DATE: January 16, 1998
TO: Montgomery County Planning Board
FROM: Wynn E. Withans, ASLA, AICP *WW*
Development Review
Planning Department Staff
(301) 495-4584
VIA: Charles Loehr, Chief, *CL*
Development Review
REVIEW TYPE: Site Plan Review
APPLYING FOR: 768 units: 75 SFD, 295 Townhouses, 398 multifamily inclusive of 96 MPDU's
PROJECT NAME: Clarksburg Town Center - Phase I
CASE #: 8-98001
REVIEW BASIS: 59-D-3 of the Montgomery County Code is required for the optional method of development in this zone.
ZONE: RMX-2, Residential Mixed Use Development, Specialty Center
LOCATION: Northeast of the intersection of Clarksburg Road and Stringtown Road
MASTER PLAN: Clarksburg Master Plan and Hyattstown Special Study Area, June 1994
APPLICANT: Clarksburg Land Associates L.P. and Piedmont Land Associates L.P. and T/A Clarksburg Town Center Venture
FILING DATE: August 1, 1997
HEARING DATE: January 22, 1998

PHASE I
SITE PLAN

8-98001 CLARKSBURG TOWN CENTER SITE PLAN

STRINGTOWN ROAD (A-260)
(MID-COUNTY HIGHWAY (A-305) TO STREET "C")

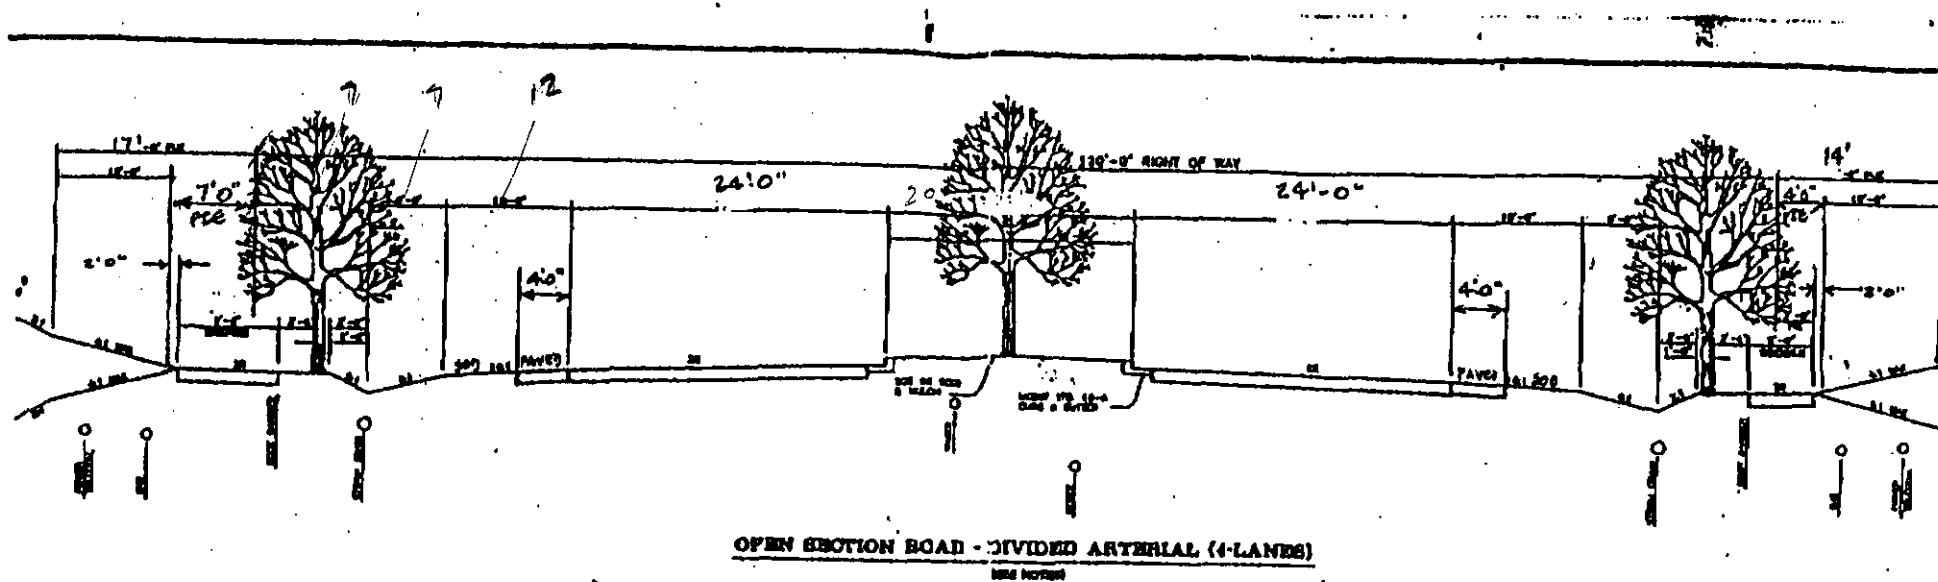
To ensure that the Applicant fund its share of road infrastructure, as best can be determined at this time, staff recommended that the Applicant improve Stringtown Road (A-260), to County standards as a two lane road within the Master Plan Alignment, No. 2. as of August 25, 1995. Staff's assessment was based on the 1993 Fiscal Impact Analysis prepared by the Montgomery County Office of Planning Implementation (OPI), as part of the Clarksburg Master Plan review. The OPI study projected a funding gap of approximately \$89 million for required infrastructure. The Study also projected approximately \$37 million in revenues to be generated by the Construction Excise Tax (CET). Since the CET has been repealed, this loss of

CLARKSBURG TOWN CENTER PARK / SCHOOL CONCEPT PLAN CLARKSBURG, MD 20871

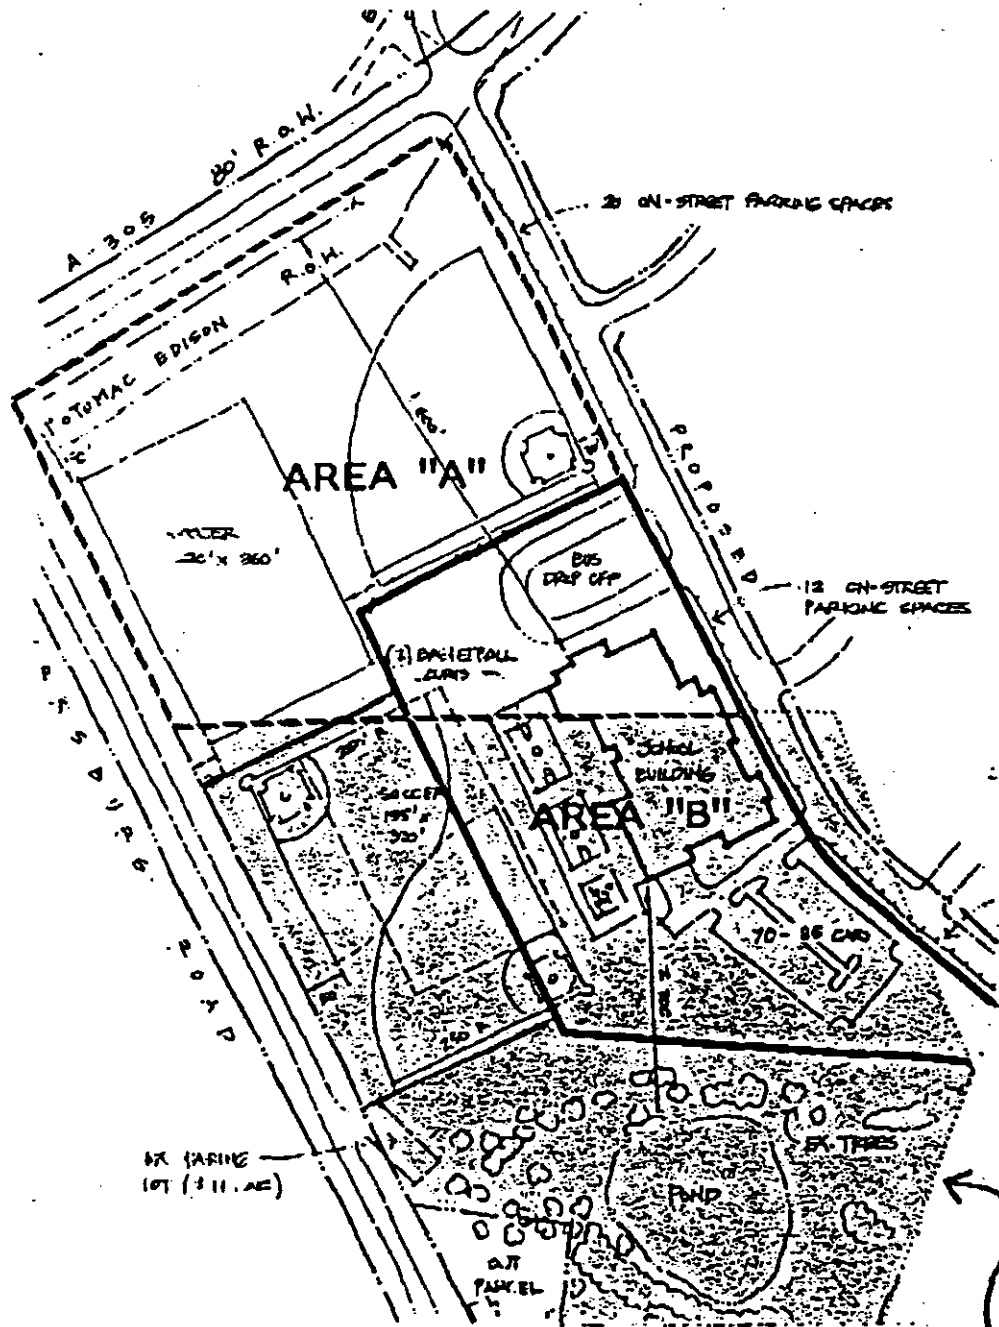
The Board of Education again requests of M-NCPPC the dedication of part of the Park/School site. This request was denied during the Preliminary Plan hearing (per memo of December 31, 1997 in Appendix). ~~This issue does not involve the applicant.~~

- (c) Stringtown Road (Master Plan A-260) for ultimate 120' right-of-way.
6. Dedication of the proposed park/school, as shown on the Applicant's revised preliminary plan drawing, is to be made to M-NCPPC. In order to facilitate the implementation of the combined park/school facilities, the following provisions apply:

- (a) M-NCPPC and the Applicant will enter into an agreement specifying that an exchange of land, identified as areas "B1" and "B2" on the park/school concept drawing set out on Circle Page 49 of the staff report, will occur prior to the execution of the Site Plan Enforcement Agreement.

- (b) Dedication of the approximately 8 acre area, identified as area "A" on the same park/school concept drawing identified above, will occur either at the time of recordation of the plats for the adjacent phase of the project or at such time as funds for construction of the future elementary school are added to the County CIP, whichever occurs first.
